HARPENDEN SOCIETY / HARPENDEN URBAN DESIGN GROUP

Upper Lea Valley Group's 2nd Interim Report

CENTRAL AREA STUDY

MARCH 1972

Fig 2 Timber fencing

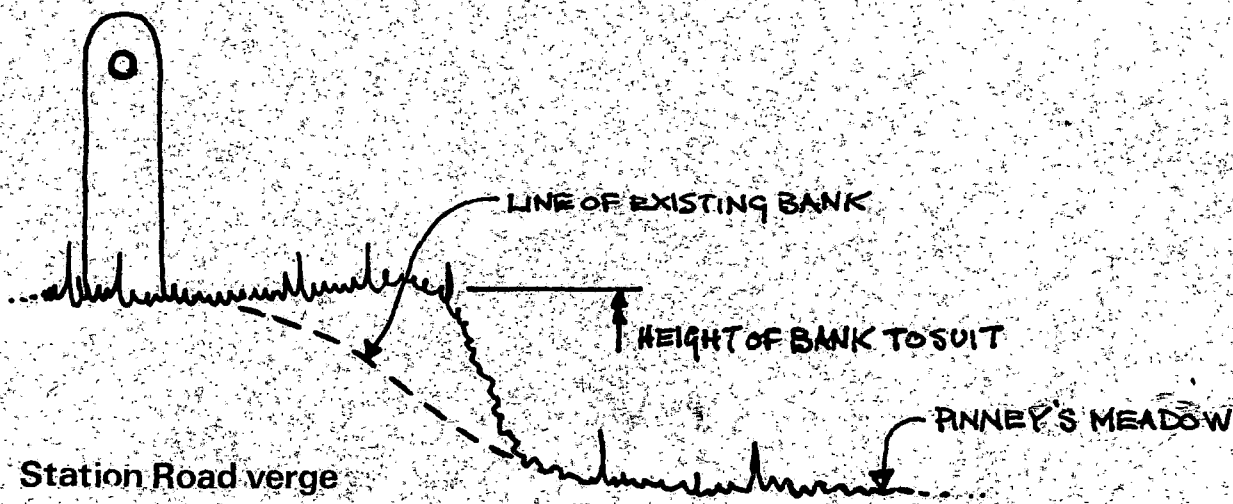
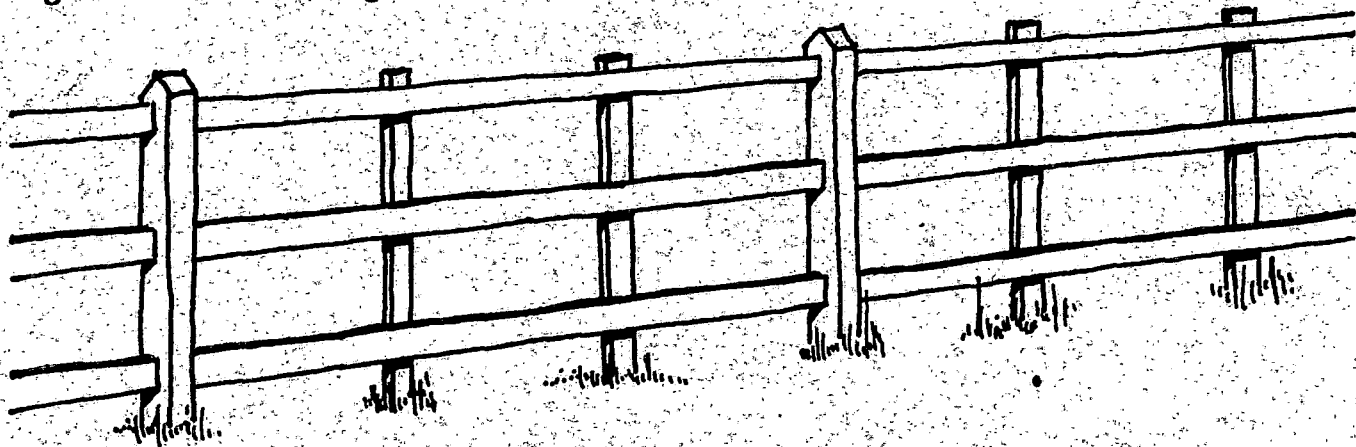
At present the hedging on the east and south boundaries is supplemented by posts and barbed wire fencing which is in a poor state of repair. This would be a good place to introduce the type of wooden fencing illustrated in Figure 2.
